**Brookside Gardens Parking Renovation, Amended Forest Conservation Plan, PP1995001**

**Completed: 11/21/13**

**Description**

- 1800 Glenallan Avenue;
- 60 acres, R-90 Zone;
- 1989 Master Plan for the Communities of Kensington-Wheaton;
- Amended Forest Conservation Plan for the renovation of the entrance and parking;
- Applicant: Montgomery County Department of Parks;
- Filing date: 5/15/2013.

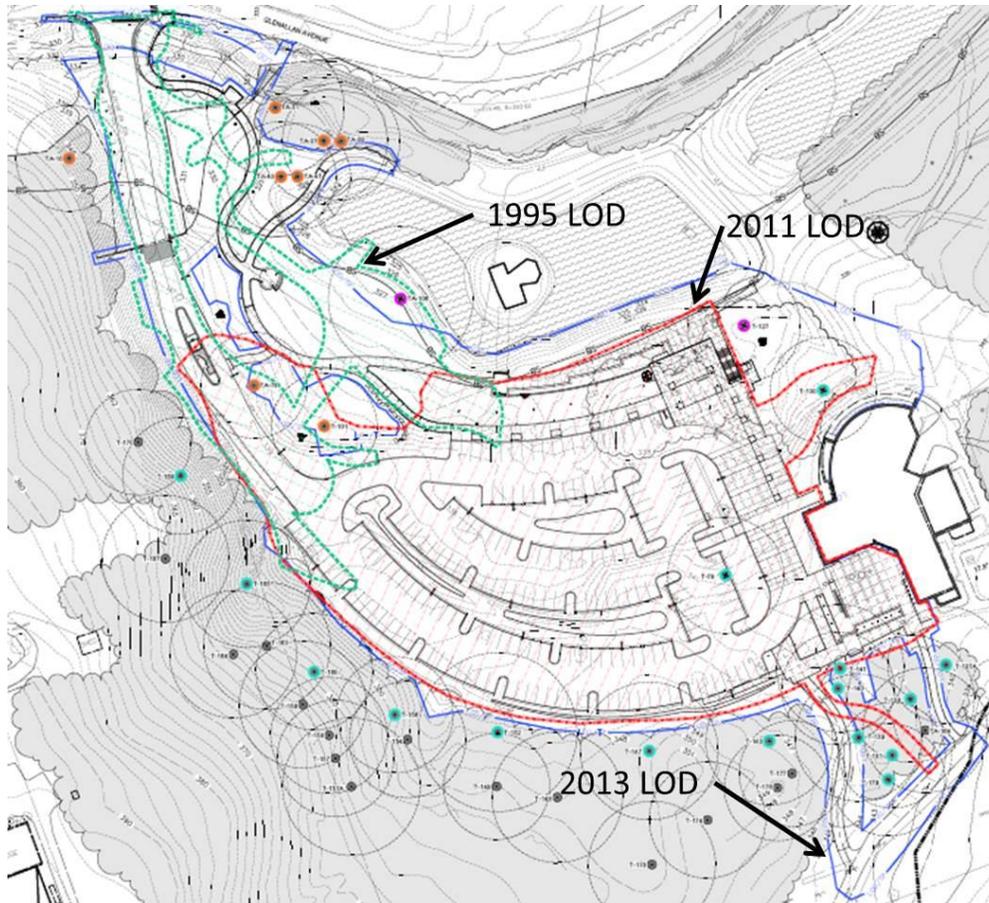
The plan proposes new pedestrian paths within the environmental buffer to connect to the existing pedestrian circulation system.

These paths will be primarily boardwalk on helical piers, except where it is necessary to connect to an existing asphalt path or to provide ADA-compliant walkways. The proposed plan also removes existing asphalt paths from within the environmental buffer. Encroachments to the environmental buffer cannot be avoided because of the need to provide connections to existing facilities and the site topography. Encroachments have been minimized through the use of minimally invasive construction techniques and mitigated with the removal of existing encroachments. Therefore, the proposed plan is in compliance with the *Environmental Guidelines*.
